South Texas Project Electric Generating Station P.O. Box 289 Wadsworth, Texas 77483

November 20, 2009  
NOC-AE-09002489  
10 CFR 50.90  
10 CFR 50.91

South Texas Project  
Units 1 & 2  
Docket Nos. STN 50-498, STN 50-499  
Response to Request for Additional Information  
Regarding License Amendment Requests for Deviation from  
Fire Protection Program Requirements (TAC Nos. ME0824, ME0825, ME1389, ME1390)

# **STPNOC RESPONSE TO REQUEST FOR ADDITIONAL INFORMATION**

**Lay-out Drawing of Fire Area 27**

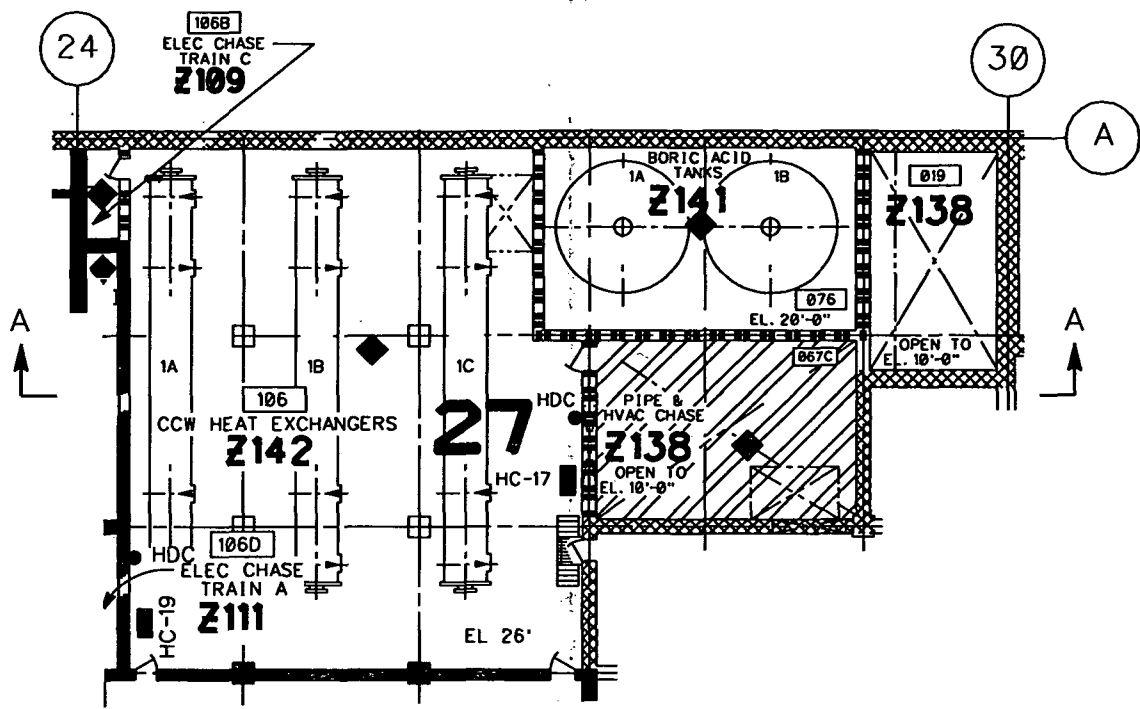
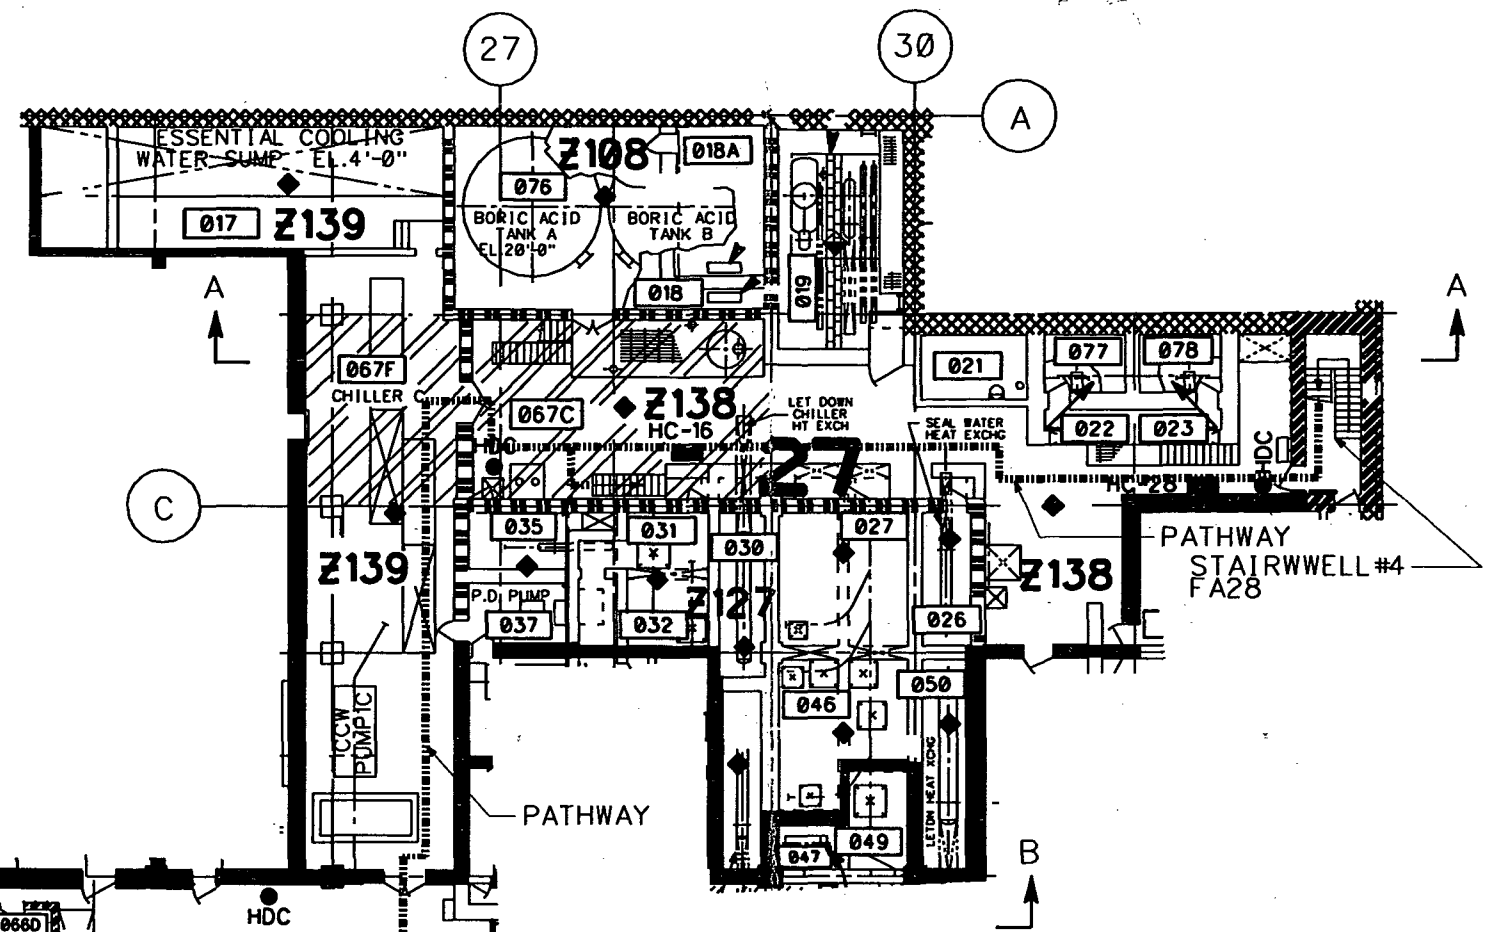
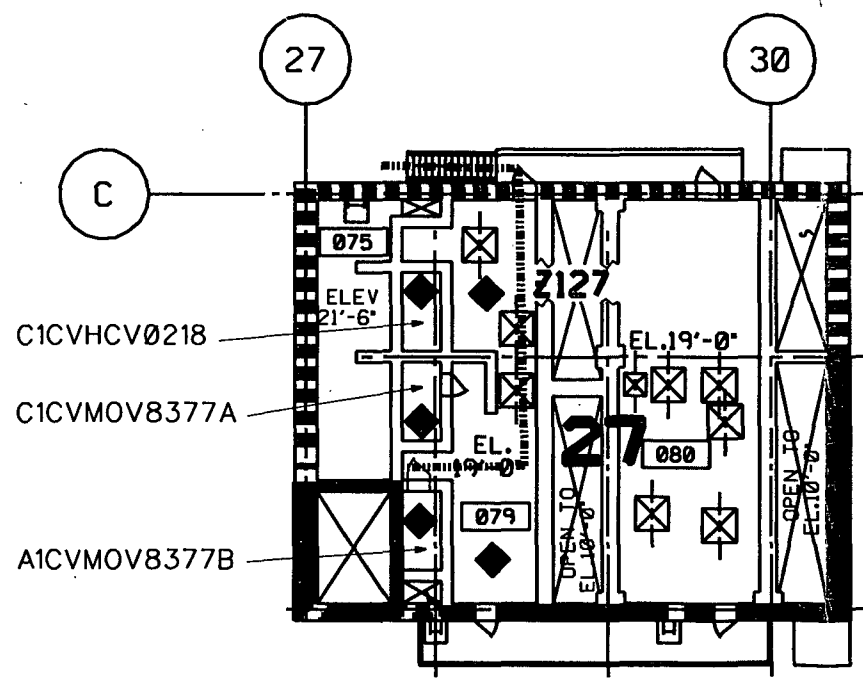
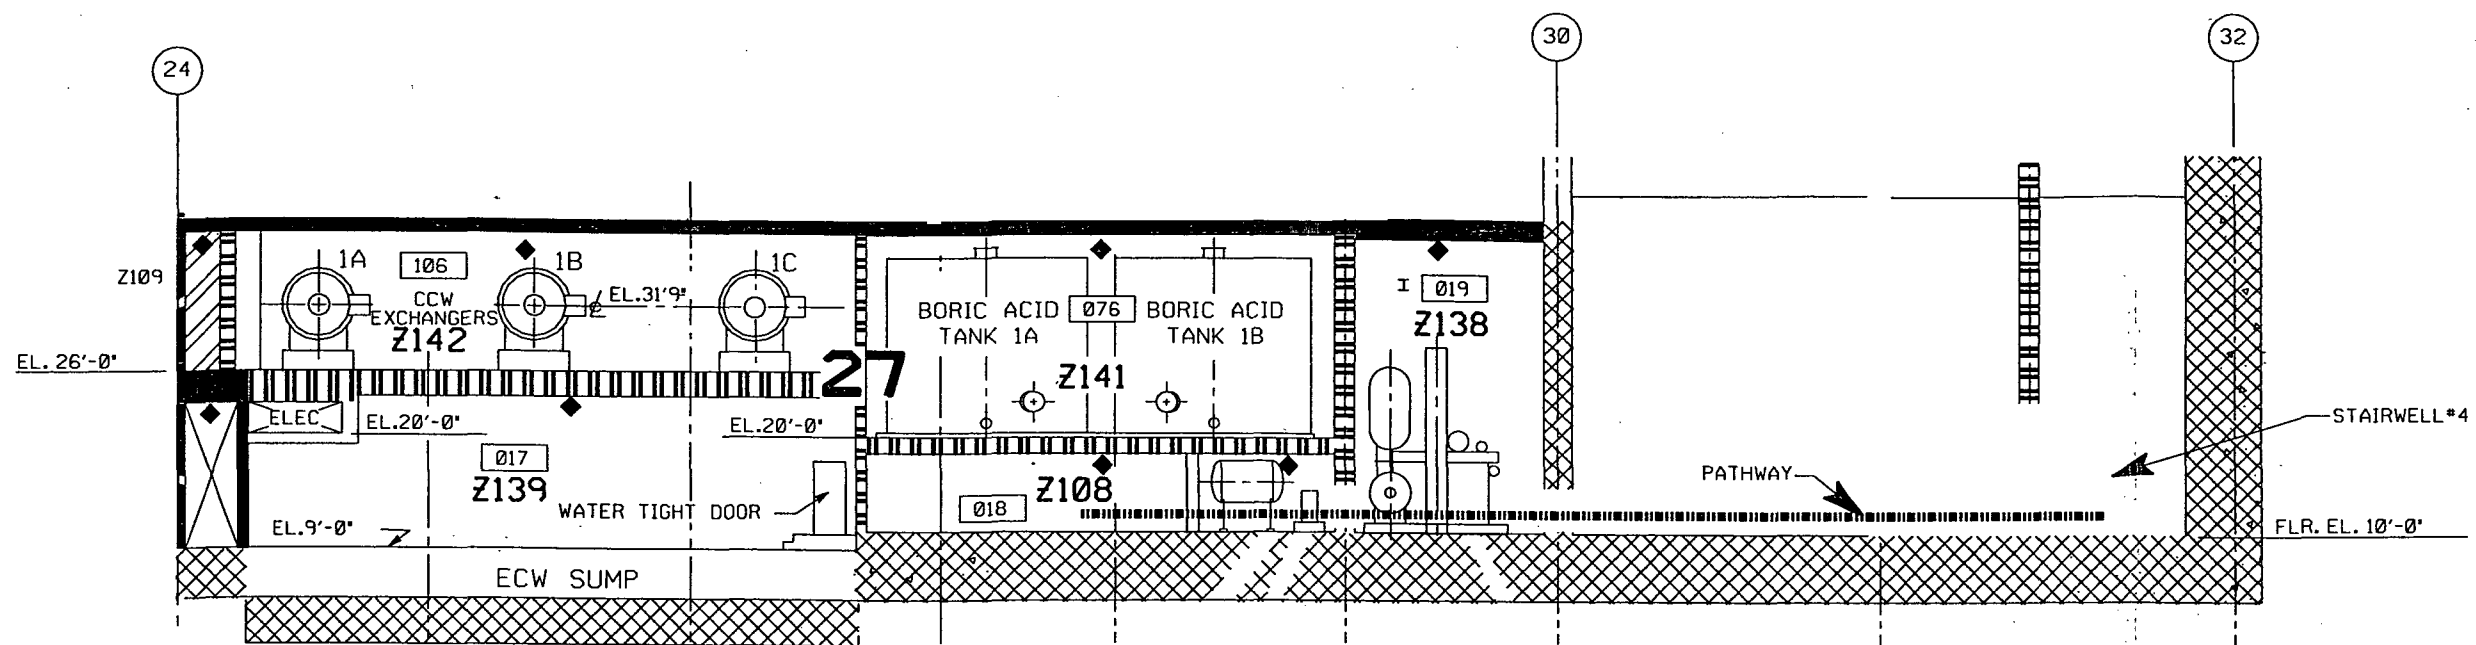
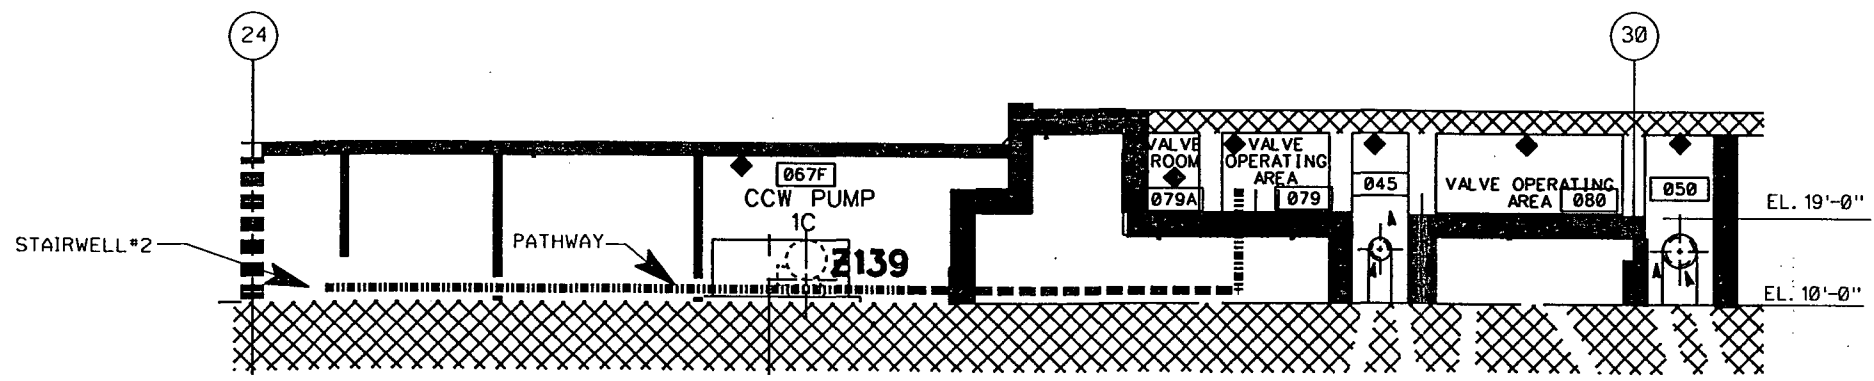
**Provide critical details and/or assumptions of the analysis that demonstrates that the path that operators are expected to traverse, as well as the space where control valve CV-MOV-8377B is located, remain tenable for operators to enter the fire zone following a fire event and fire brigade operations including scenarios requiring the use of SCBA.**

Attachment 1 to this enclosure provides a lay-out drawing of Fire Area 27 and the fire zones within this area including the access pathway to valve CV-MOV-8377B. Attachment 5 to the Enclosure in Reference 2 provides a zone-by-zone analysis that demonstrates that the path that operators are expected to traverse, as well as the space where valve CV-MOV-8377B is located, remain tenable for operators to enter the fire zone following a fire event and fire brigade operations. The key conclusions of this analysis are repeated below:

The lay-out drawing of Fire Area 27 is provided as Attachment 1 to this Enclosure.

The circuitry for the air-operated solenoid valves to operate CV-HCV-0218 is located in Fire Area 27. Valve CV-HCV-0218 is located in Fire Zone Z127 in another separate valve cubicle room with solid concrete walls (see Attachment 1).

The following discussion provides the critical details and assumptions of the analysis that demonstrates that the path that operators are expected to traverse, as well as the space where control valve CV-MOV-8377B is located, will be accessible.

For smoke and heat removal in Fire Area 27, a series of portable exhaust fans and flexible duct are used to exhaust smoke and heat from the area via stairwell #2 (see Attachment 1). The portable exhaust fan is used to exhaust the smoke and heat to the atmosphere via the door at the top of the stairwell per Fire Pre-plans for Fire Area 27. This stairwell #2 is an alternate pathway to access/egress Fire Area 27. Stairwell #4 (see Attachment 1) is the primary pathway to access the area in the event of a fire. The arrangement to exhaust should have no impact on the primary access/egress pathway to support the operator manual action to re-enter Fire Zone 27.

### **Safe Shutdown Manual Action Timelines for Fire Areas 27 and 31.**

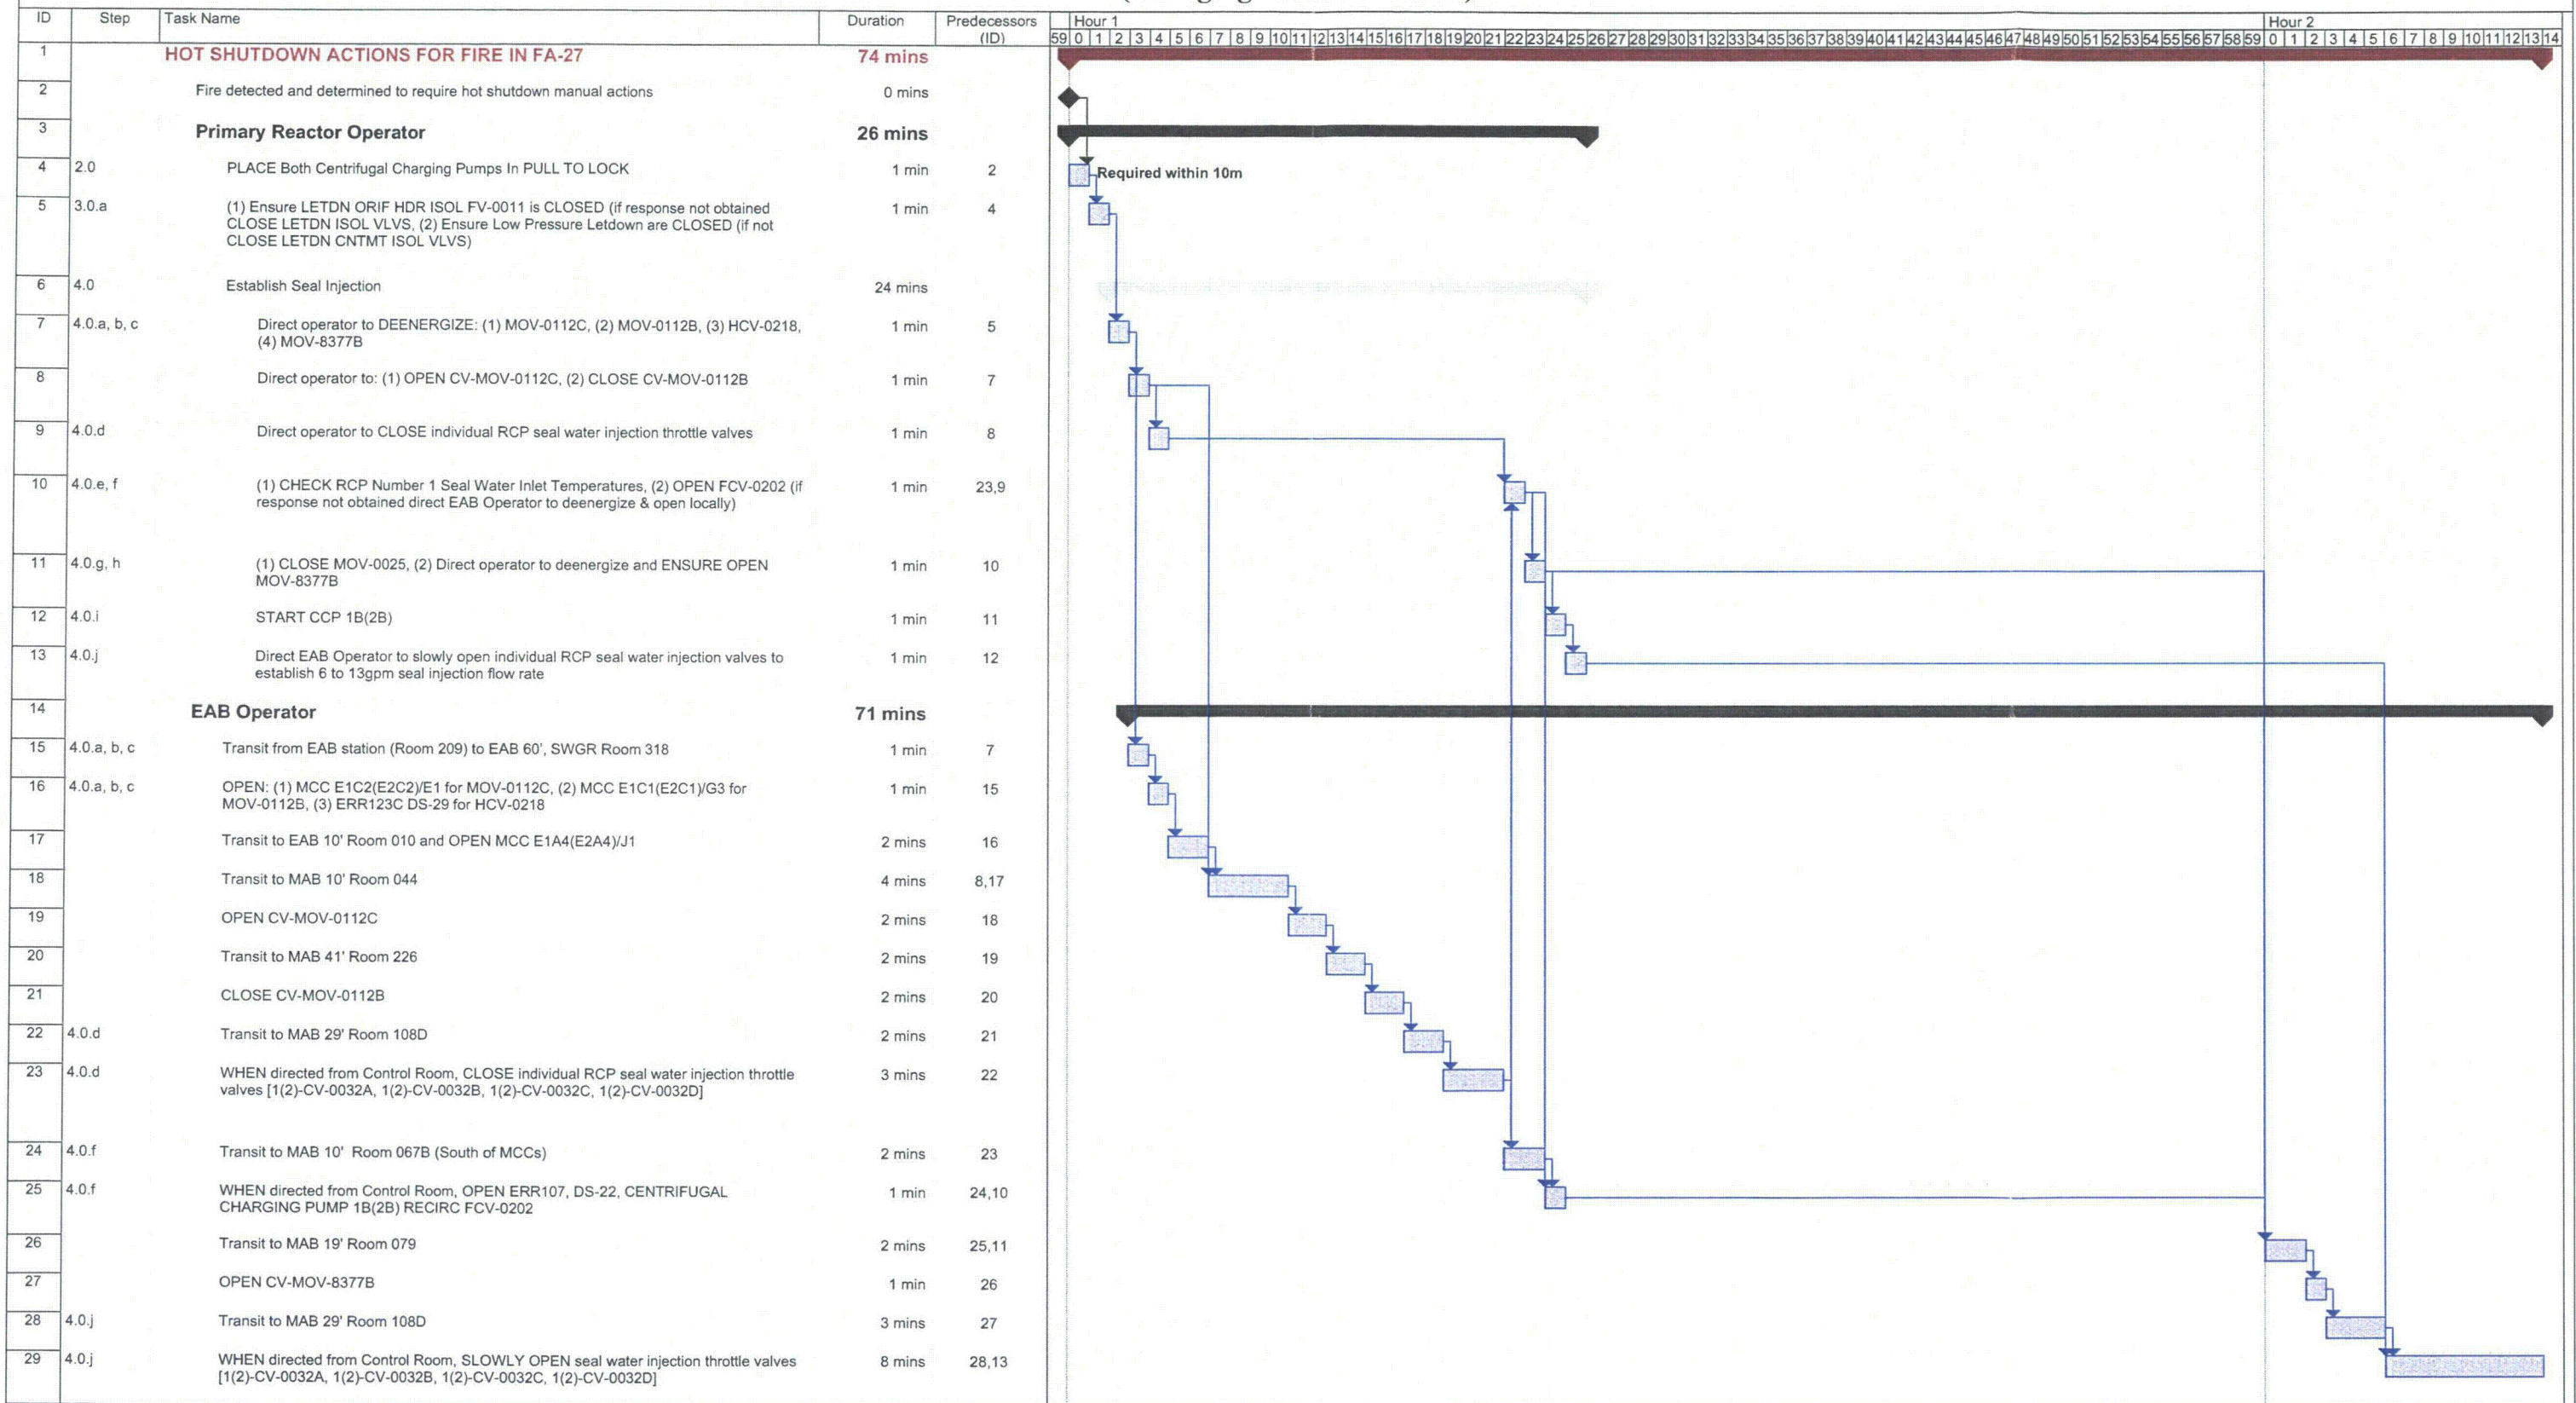
**Describe the circumstances and assumptions needed to enter the OMA procedure. For example, describe the amount of time, and the technical basis, that has been assumed for detection and assessment of a postulated fire. Additionally, provide an analysis and a technical justification to evaluate scenarios where components fail, or damage occurs, before a fire has been detected.**

Attachment 2 provides the validated safe shutdown manual action timelines for Fire Areas 27 and 31.
